**Operational Test and Evaluation
(OT&E) Operational Air Traffic
Control Evaluation for the
Prototype Airport Surveillance
Radar Wind Shear Processor
(ASR-WSP) at Albuquerque
International Airport**

March 1994

DOT/FAA/CT-TN94/4

FIGURE 1. SITUATION DISPLAY WINDOW LAYOUT

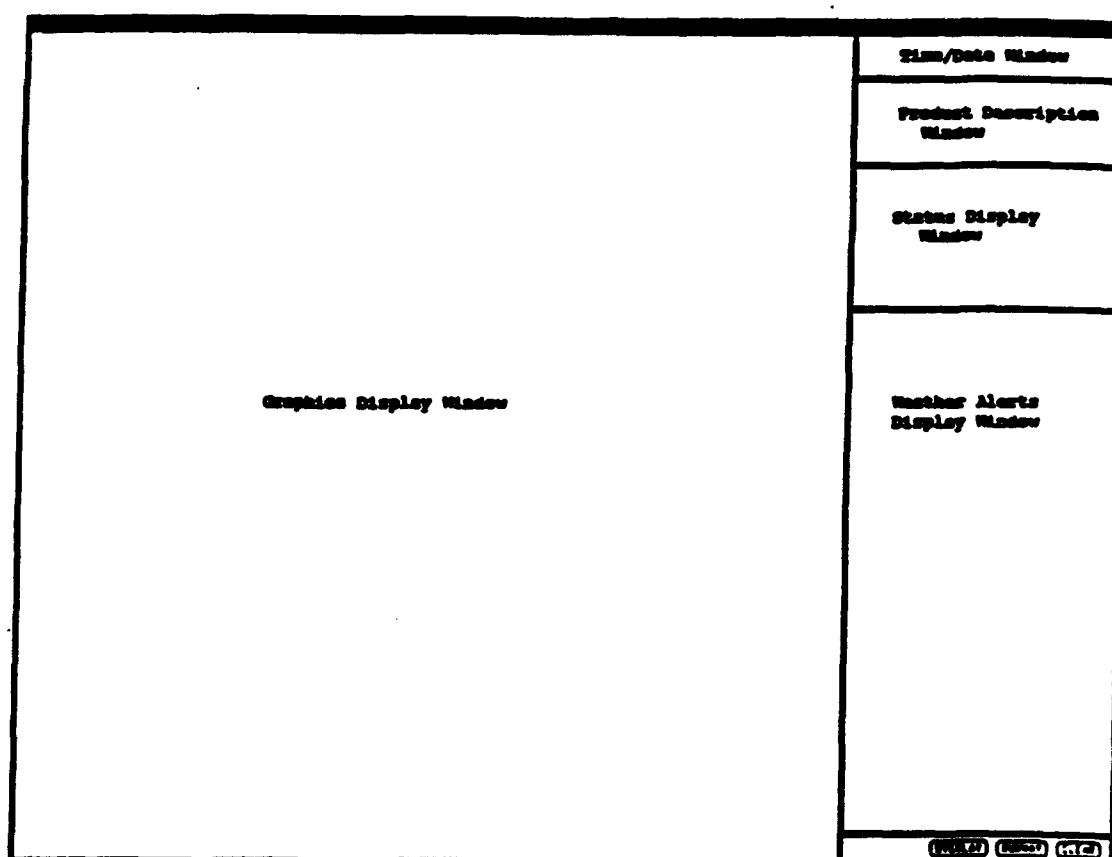
Situation Display. The situation display window layout graphic display was rated Good or Very Good by 88.2 percent of the respondents. One participant (5.9 percent) rated the graphic display Fair. One participant (5.9 percent) responded "do not know" to the question about the situation display window layout graphic display.

The situation display window layout of the weather alerts display was rated Good or Very Good by 88.2 percent of the respondents. One participant rated the weather alerts display Fair. One participant responded "do not know" to this question.

The situation display window layout of the status display was rated Good or Very Good by 88.2 percent of the respondents. One participant (5.9 percent) rated the display Fair. One participant (5.9 percent) responded "do not know" to the question about the status display of the situation display window.

The situation display window layout product description was rated Good or Very Good by 88.3 percent of the respondents. One participant (5.9 percent) rated the product description Fair. One participant (5.9 percent) responded "do not know" to the question.

The situation display window layout for the time/date was rated Good or Very Good by 82.3 percent of the respondents. Two participants (11.8 percent) rated the time/date Fair. One participant (5.9 percent) responded "do not know" to the question.

Discussion: Overall, all situation display window layouts were rated Good or Very Good by more than 80 percent of participating respondents. There were no additional user comments about the situation display window on the questionnaires. The situation display window layouts appear to be satisfactory from the perspective of the user participants.
